SUNDRY NOTICES AND REPORTS ON WELLS OCT 1 6 20126. If Indian, Allottee or Tribe Name

1. Type of Well ✓ Oıl Well Gas Well Other					8. Well Name and No. Gaucho Unit 6		
Name of Operator Devon Energy Production Company, L.P.				9 API Well No. 30-025-34789			
3a. Address 333 West Sheridan Ave , Oklahoma City, OK 73102-5010 405-235			O IO CHISO W		10 Field and Pool or Ex OJO CHISO, W. MOF	•	
4 Location of Well (Footage, Sec., T.,R.,M., or Survey Description) 660 FSL & 660 FEL, SEC 17 T22S R34E, Unit "P"					11 Country or Parish, State Lea County, NM

NM-92781: Gaucho Unit #6 Plug Back sundry dated 09/21/2012 API: 30-025-34789

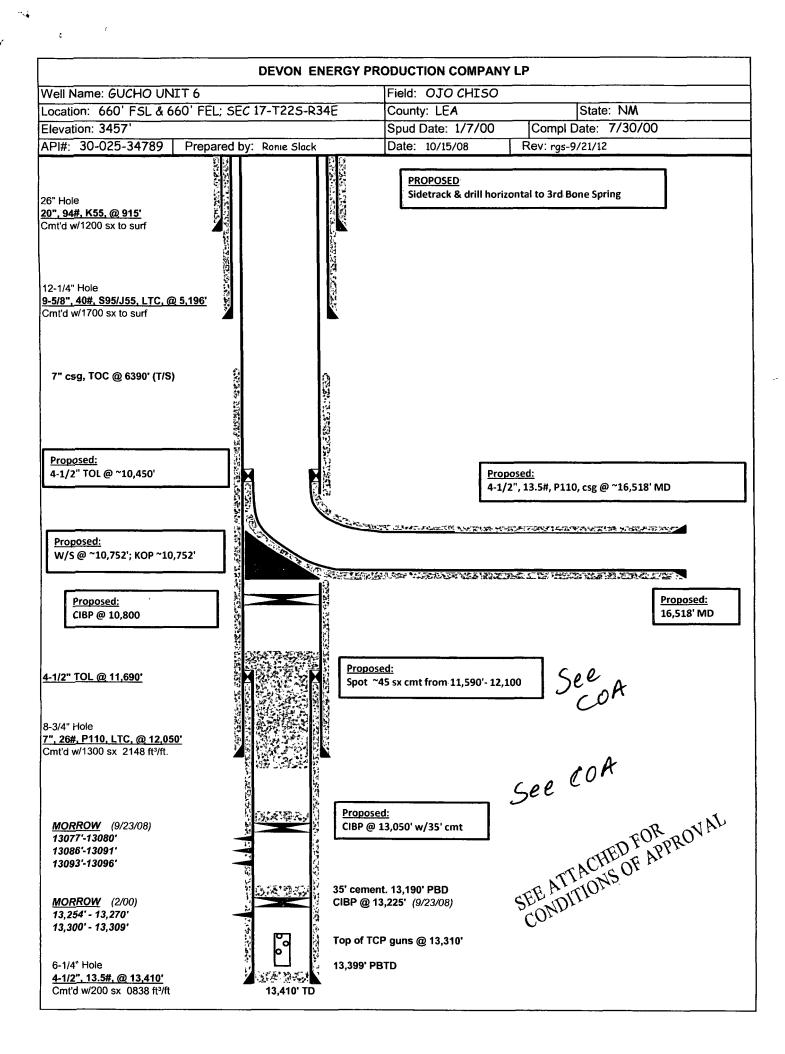
Based on current wellbore diagram submitted (plugs to be Class H due to depth)

- 5. Operator to RIH and set a top of Morrow plug at 12,940' to 12,712' WOC
- 6. NEXT fill casing with 2% KCL water and Pressure test casing to 1,000 psi to test for leaks at liner top. Hold for 15min on a chart recorder and submit Chart recorder to BLM

- 7. Run a CBL from 12,100 feet to 5050 feet to evaluate cement behind 7" casing. Submit CBL to BLM for evaluation ASAP
- 8. Wait for approval from BLM before proceeding to next step

- 9. Continue with operators step 3 on sundry, WOC and TAG plug at 11,523' or shallower to be witness by BLM (liner and shoe plug)
- 10. Operator's Step #4 not allowed <u>Procedure requires</u> a Top of <u>Wolfcamp plug</u> from 11,600 feet to 11,385 feet. WOC and Tag plug at 11,385 feet or shallower.
